LSD Ebersole Center Food Service Bid Pack 2, Addendum No. 1

Narrative of Changes

Project Name:	Ebersole Center Food Service – Equipment Replacement & Renovations SO-1853	Date:	April 3, 2026
Project Location:	3400 2 nd St Wayland, MI 49348	Architect's Project #:	26000750A
Owner/Client:	Lansing School District	Attention:	David Beckering
Issued to:	Beckering Construction	Email:	djb@beckering.com
City/State:	Grand Rapids, MI	Zip:	49548

DRAWING NUMBER:
EL101

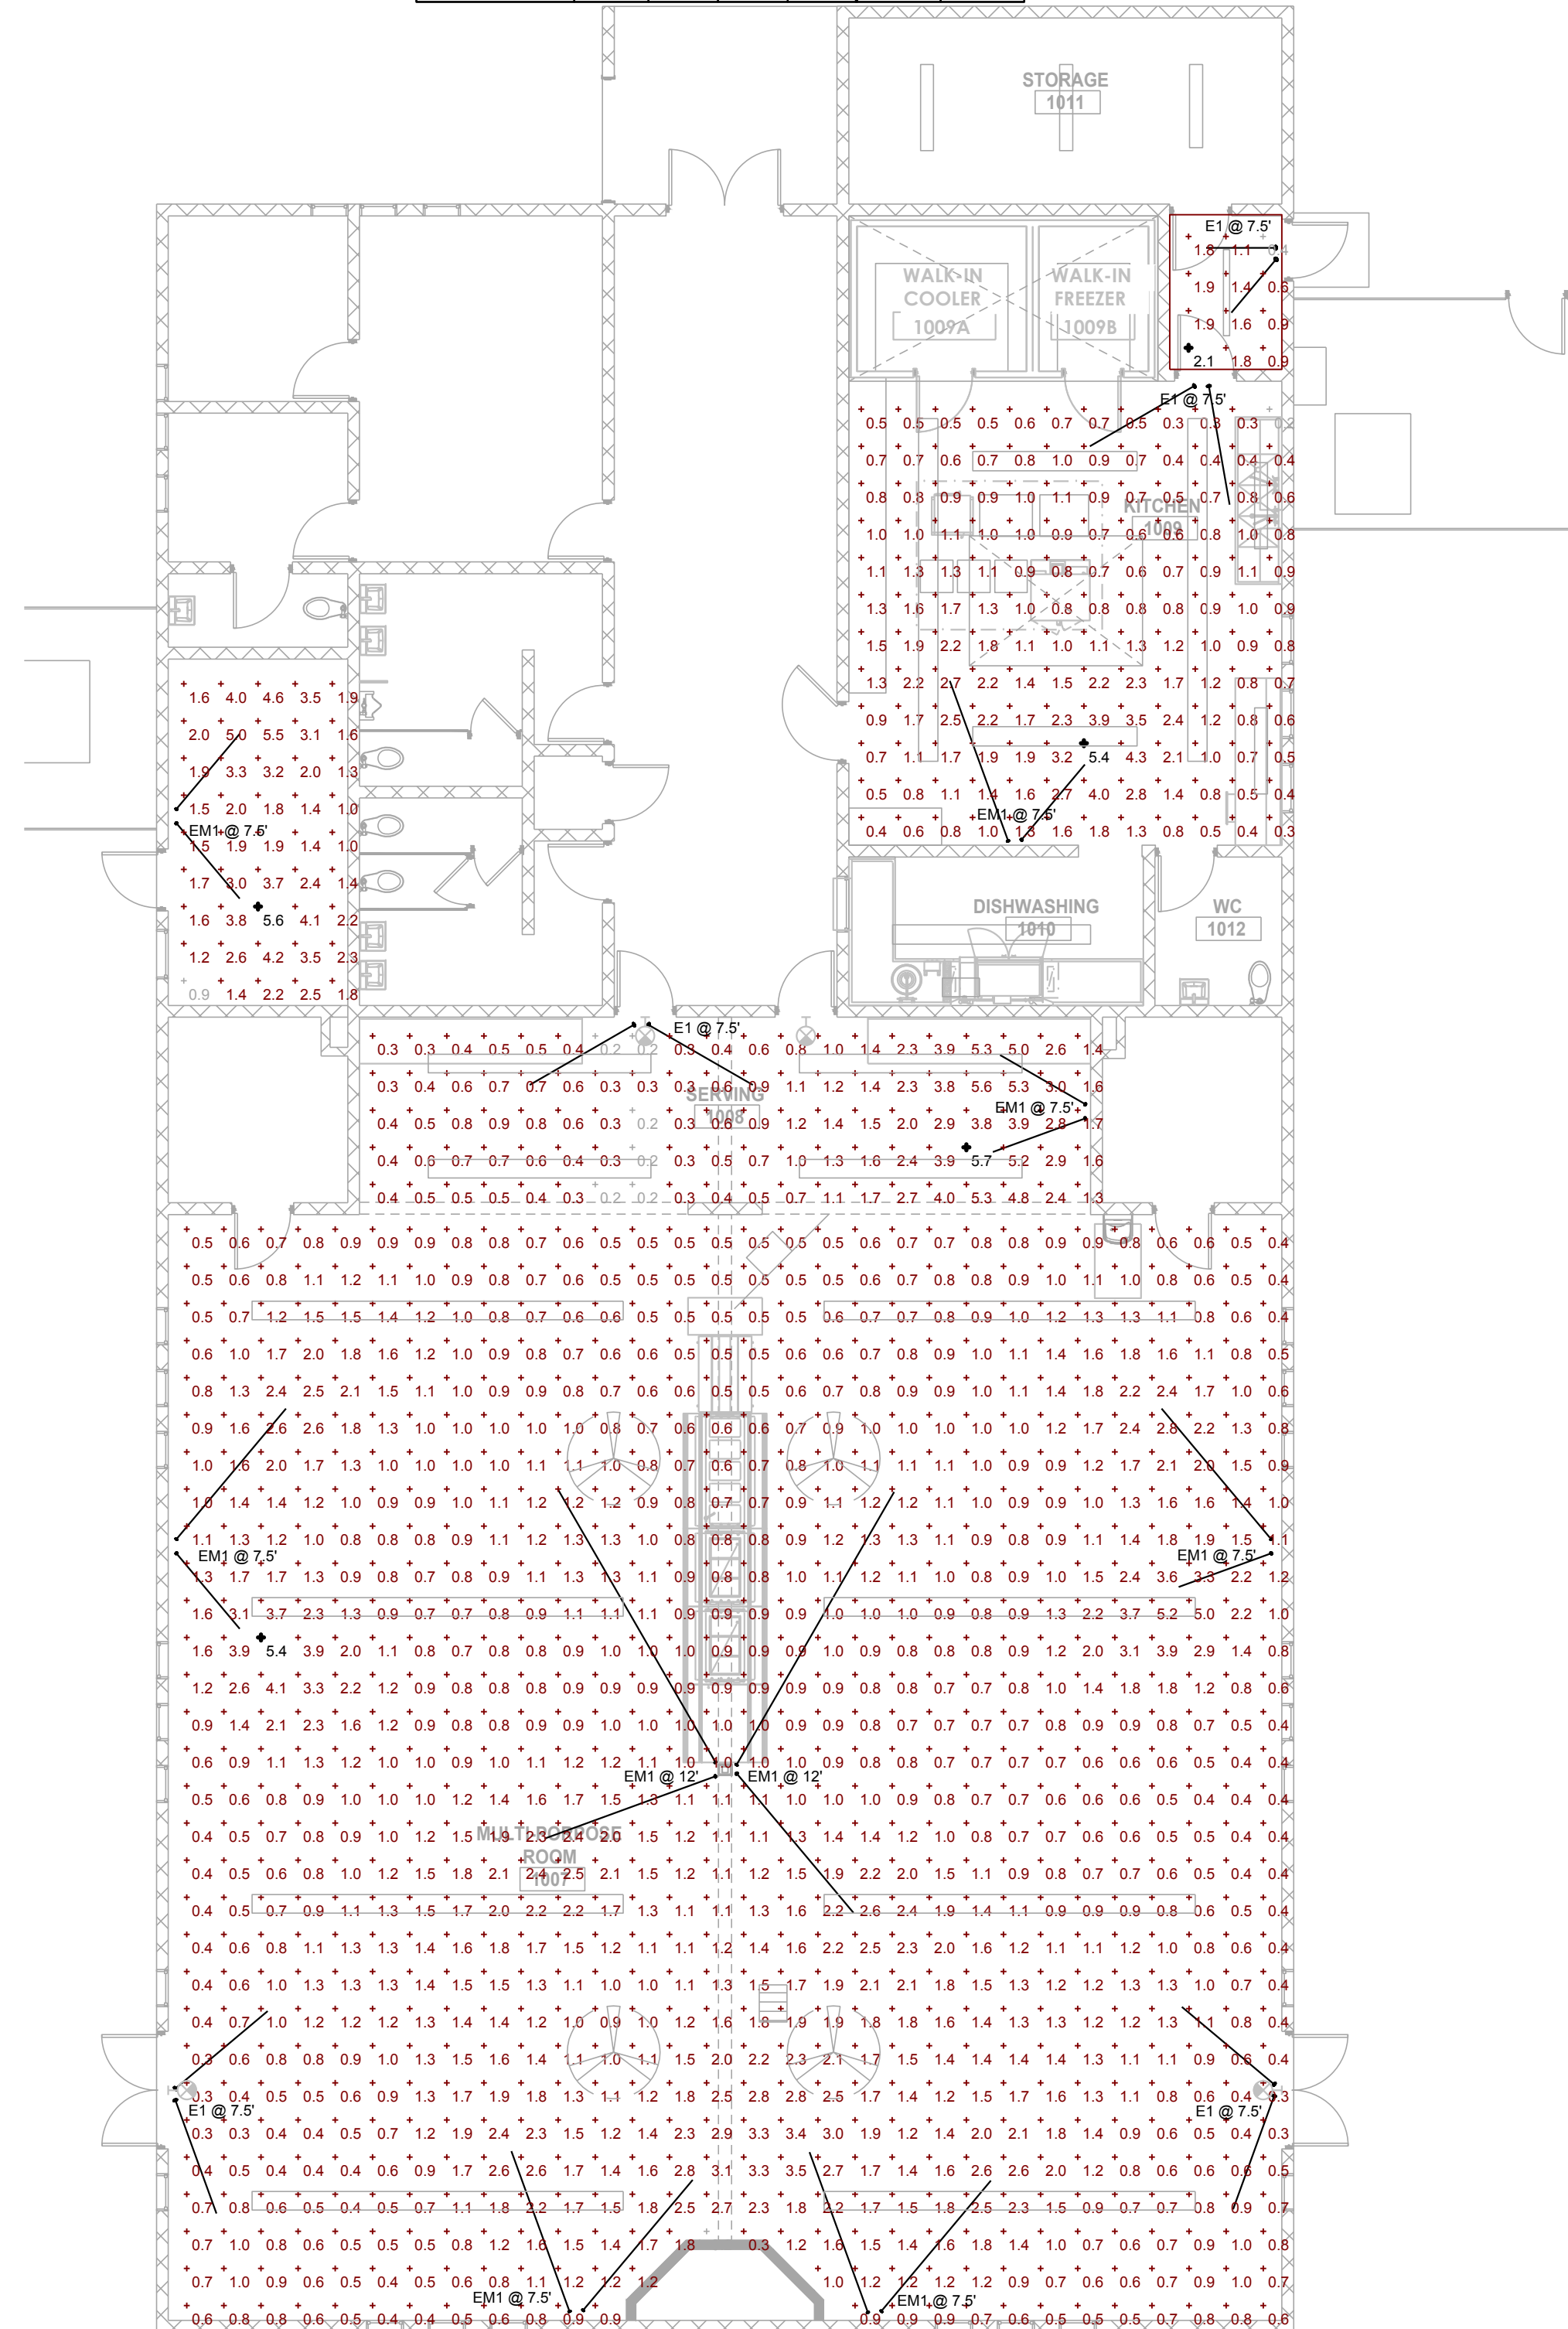
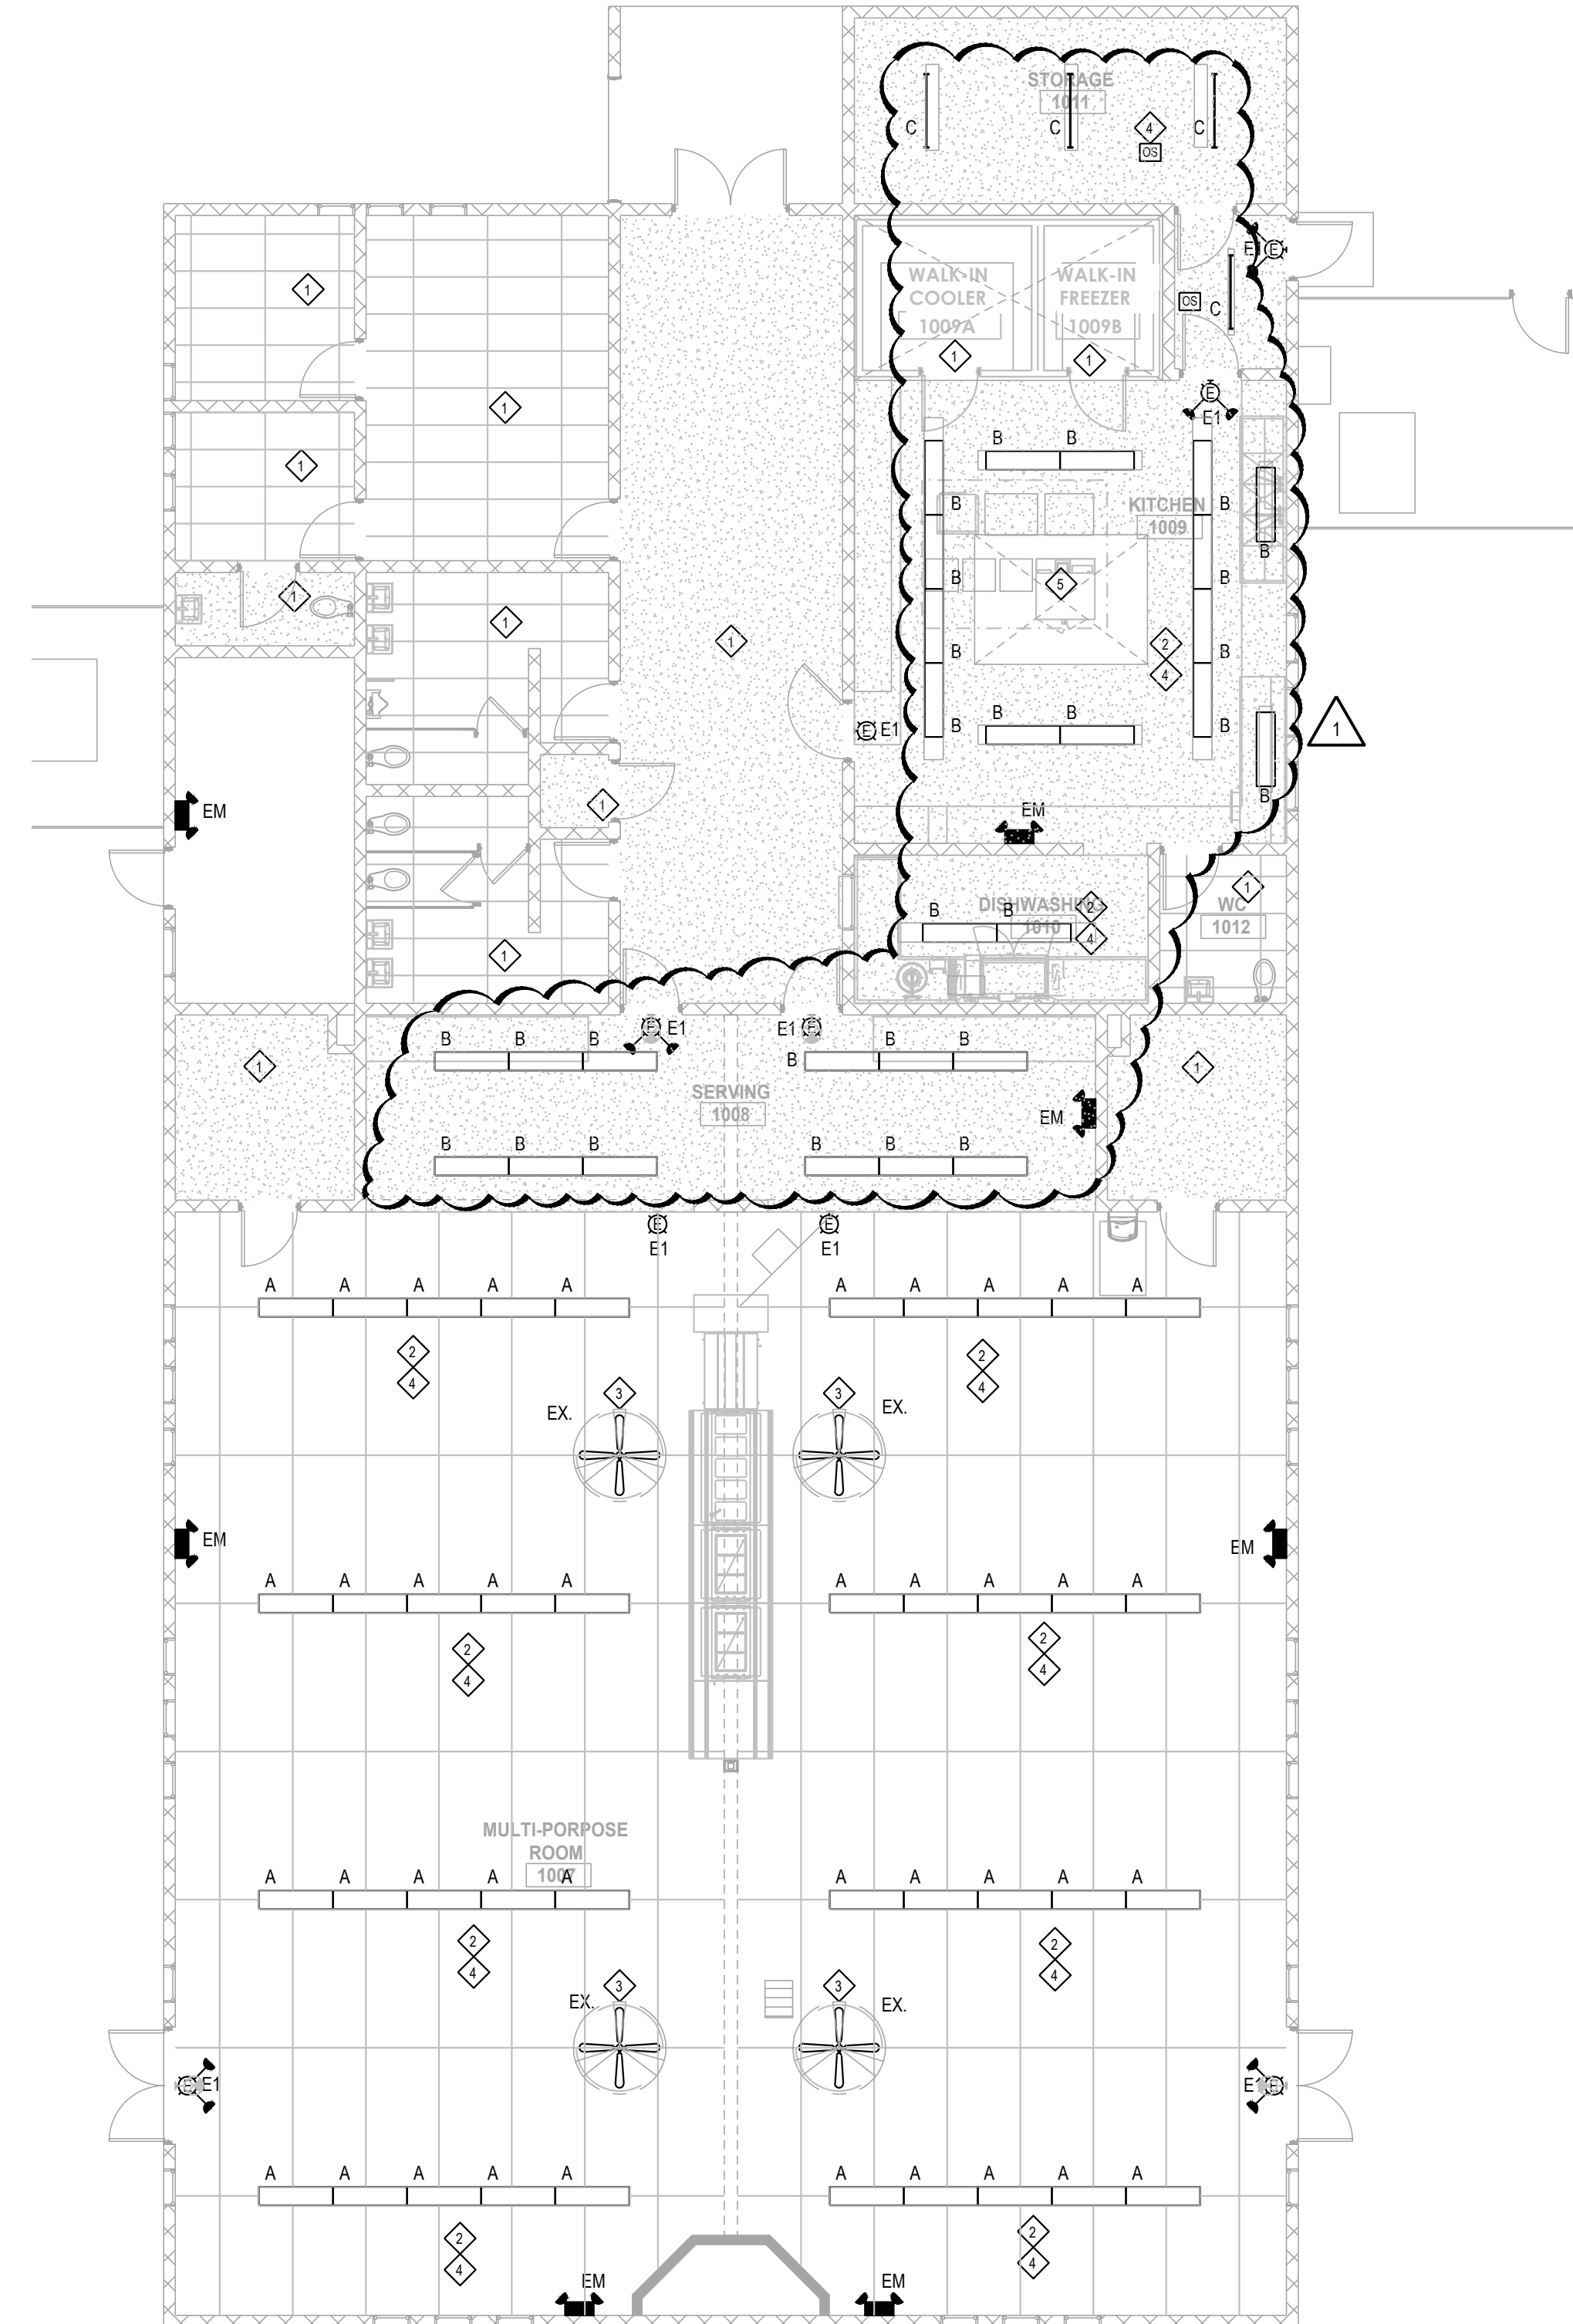
- EL101 – FIRST FLOOR PLAN – LIGHTING / PHOTOMETRICS (Reissued)
 - Changed fixtures in kitchen and serving 108 to type B
